REMARKS

II. OBJECTIONS TO THE DRAWINGS

FIG. 4

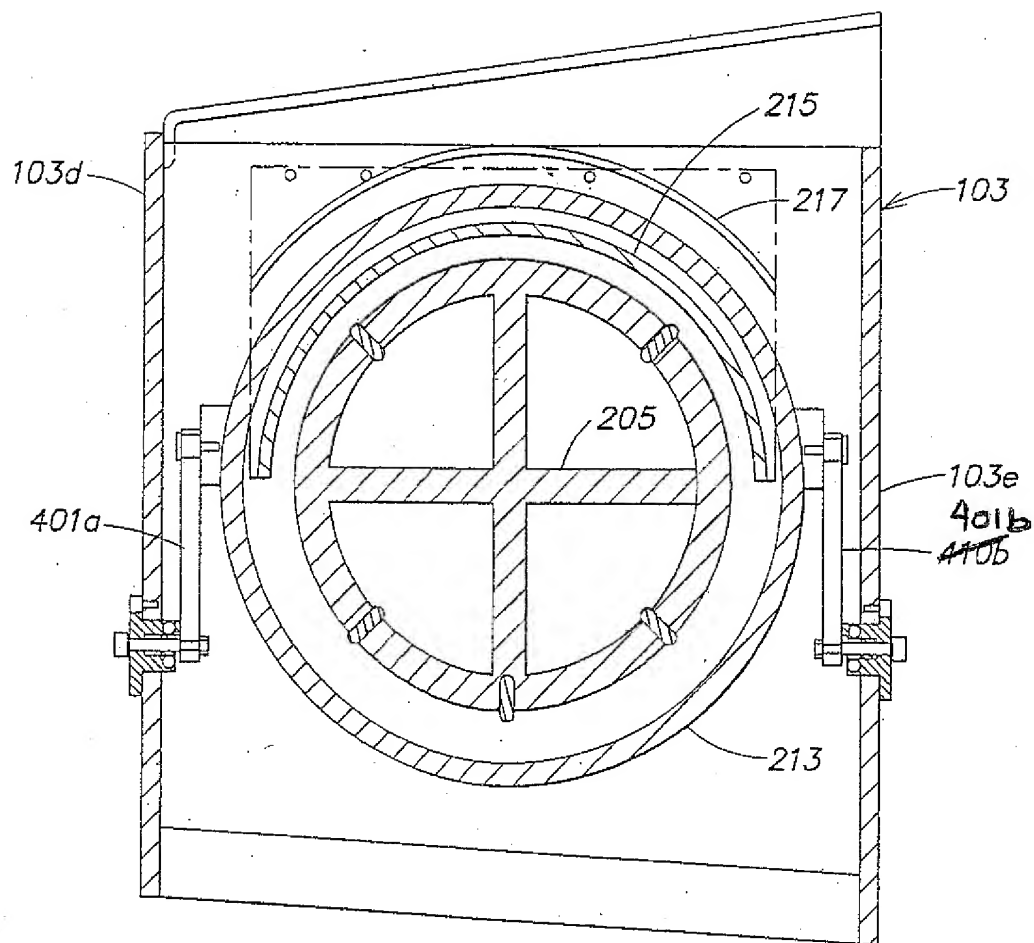
FIG. 4 is objected to because of inconsistencies between the drawing and Applicants' Specification. Accordingly, replacement FIG. 4 is included to properly indicate reference numeral 401b.
